**STAFF RECOMMENDATION**  
**1502 Franklin Avenue**  
**August 21, 2019**

**Application:** New Construction--Addition  
**District:** Eastwood Neighborhood Conservation Zoning Overlay  
**Council District:** 06  
**Base Zoning:** R6  
**Map and Parcel Number:** 08305036000  
**Applicant:** Lindsey Sullivan and Kristian Marcy  
**Project Lead:** Paul Hoffman; [paul.hoffman@nashville.gov](mailto:paul.hoffman@nashville.gov)

**Description of Project:** This application is for a rear addition. A portion of the addition goes wider than the roof of the historic home.

Figure 2: Footprint in 1957 shows the rear porch was not yet enclosed.

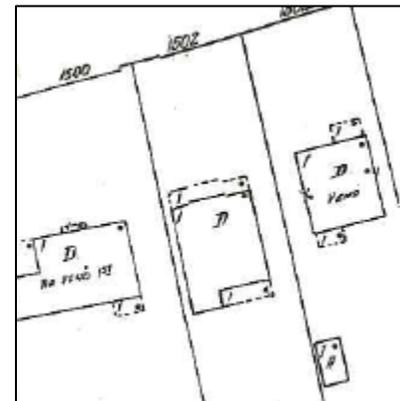
**Demolition:** An enclosed rear porch of three hundred and eight square feet (308 sq. ft.) will be removed to accommodate the new construction. The existing rear addition was an original porch enclosed after 1957 (Figure 2). It does not contribute to the architectural or historical character of the building due to the changes and its minimally-visible location. An existing shed in the rear yard is also proposed to be removed. This structure, built after 1957, is not contributing, and its demolition is in accordance with the design guidelines.

Staff finds that the proposed partial demolition meets Sections II.B.1 and II.B.2 for appropriate demolition.

Figure 4: The wide line added to the roof plan shows the ridge that will be lost with the proposed addition.

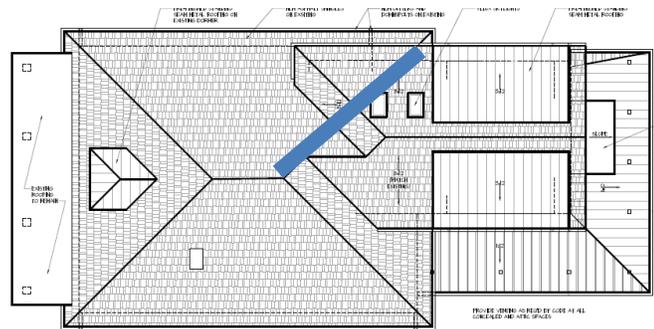
With the condition that the left side of the addition is moved behind the existing rear left ridge of the hipped roof, staff finds that the location and removability meet Section II.B.2.a and d.

Figure 3: Staff recommends this portion of the addition be moved behind the historic roof. The existing roof form is on the right and the arrow denotes the portion of the addition that cuts into the original roof form.

With the revision to the left side, staff finds that the character of the addition does not contrast with the historic building, therefore it will meet Section II.B.2.c.

**1** Roof Plan  
 1/8" = 1'-0"

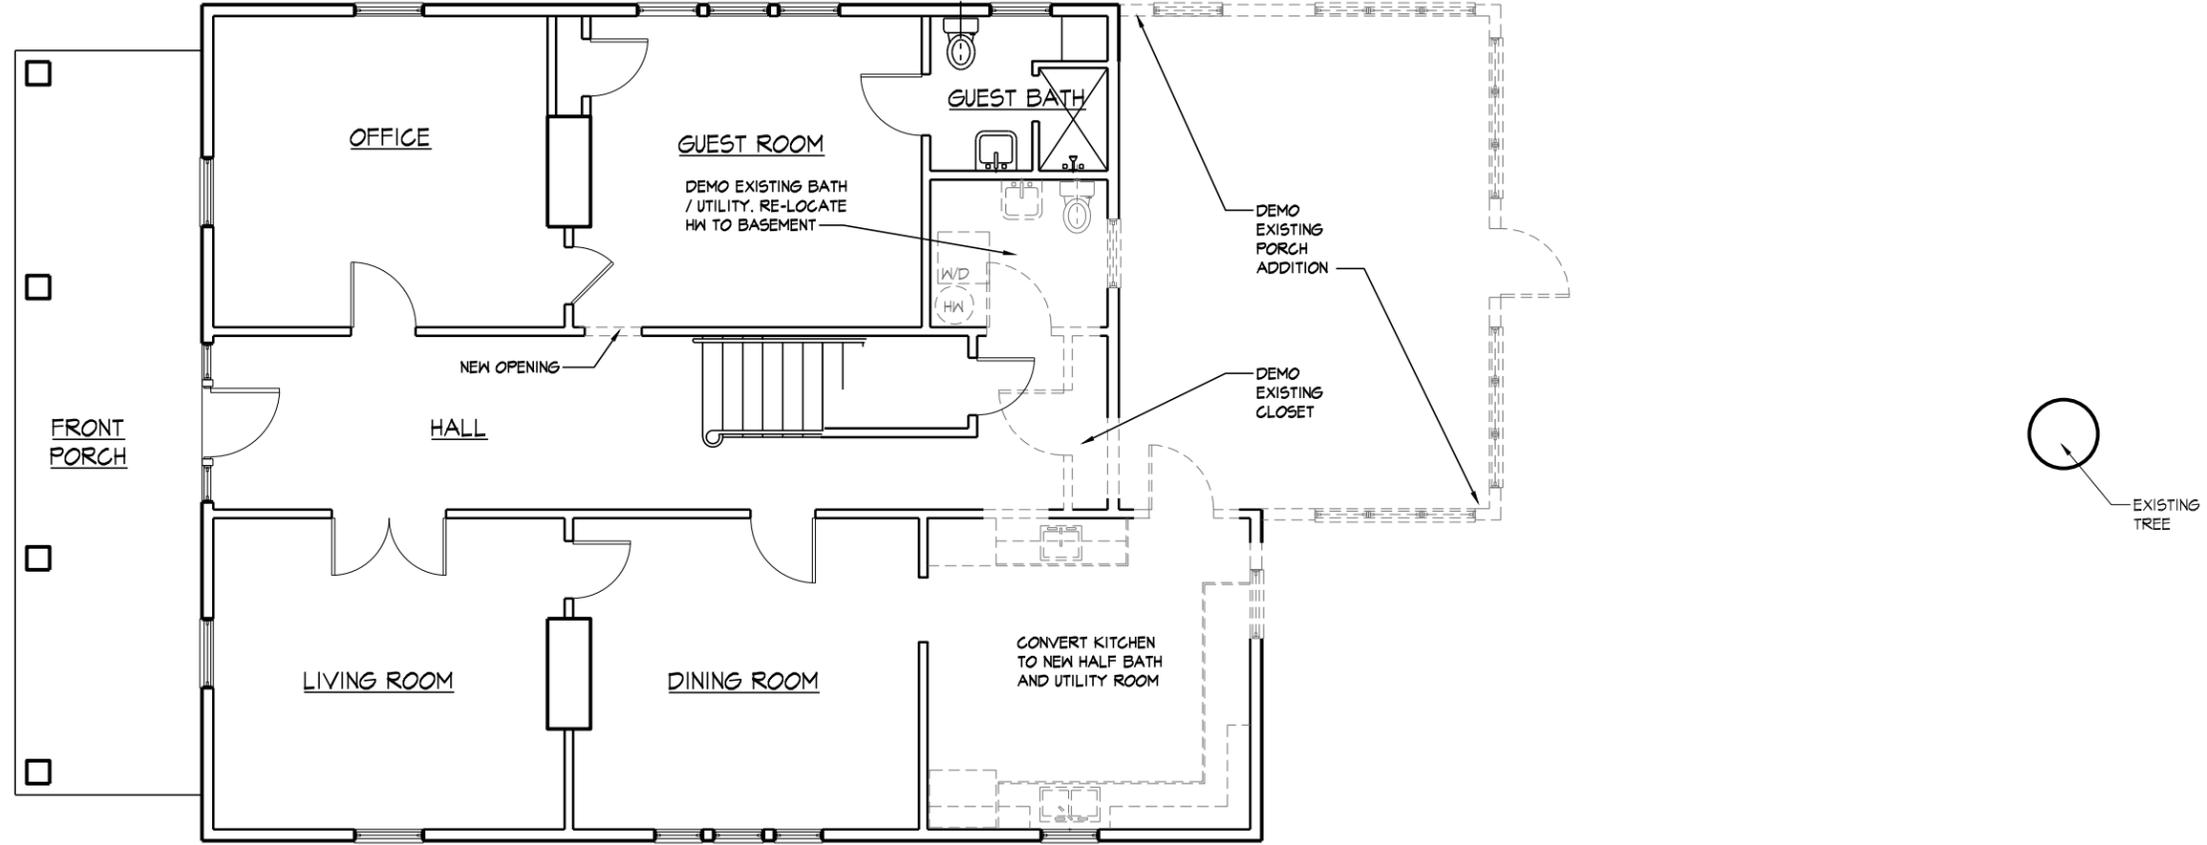
Roof form: The addition has a hipped roof with 8/12 pitch. The forward portion of the roof intrudes over the existing roof (see section on “Location & Removability.”) The addition includes a wall dormer on each side. Wall dormers are not appropriate in every instance; however, because of their small scale and the fact that wall is inset from the wall of the home, staff finds the dormers to be appropriate.

With the condition that the addition’s roof is moved behind the existing roof, staff finds that the project will meet Section II.B.1.e and II.B.2.
